Subject: BUZZING NOISE FROM DRIVER'S SIDE OF DASHBOARD	Bulletin No: 09-040/14
	Last Issued: 09/18/2014

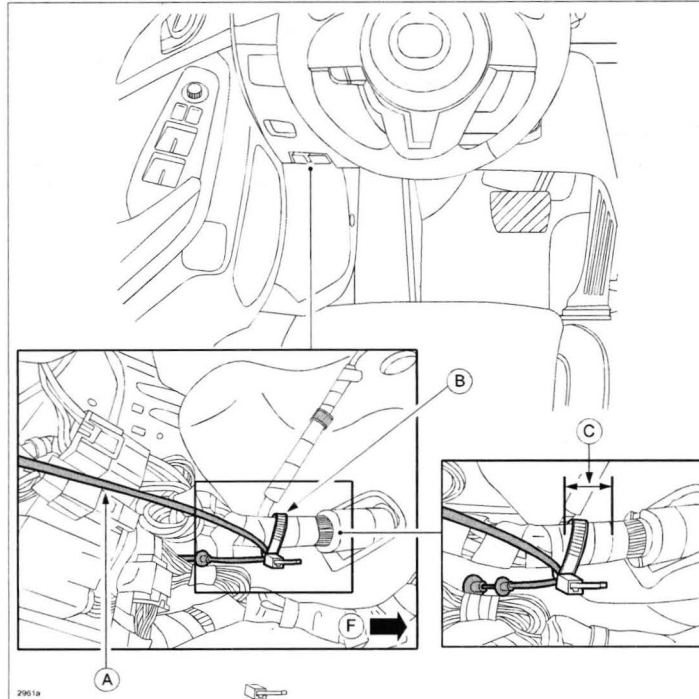
Some vehicles may exhibit a buzzing noise from the driver's side dashboard when driving on a rough road. This noise may be caused by the hood release inner wire contacting the outer cable. To correct the problem, the configuration of the hood release cable has been changed.

1. Verify customer concern.
2. Change the installation layout (bending angle) of the hood release cable in order to avoid the inner wire shaking in the outer cable when driving on rough roads.
 - a. Re-position the hood release cable to the harness (F=front of vehicle).
 - b. Secure the cable (A) to the harness with a zip tie (B) within the area indicated by the arrow (C).
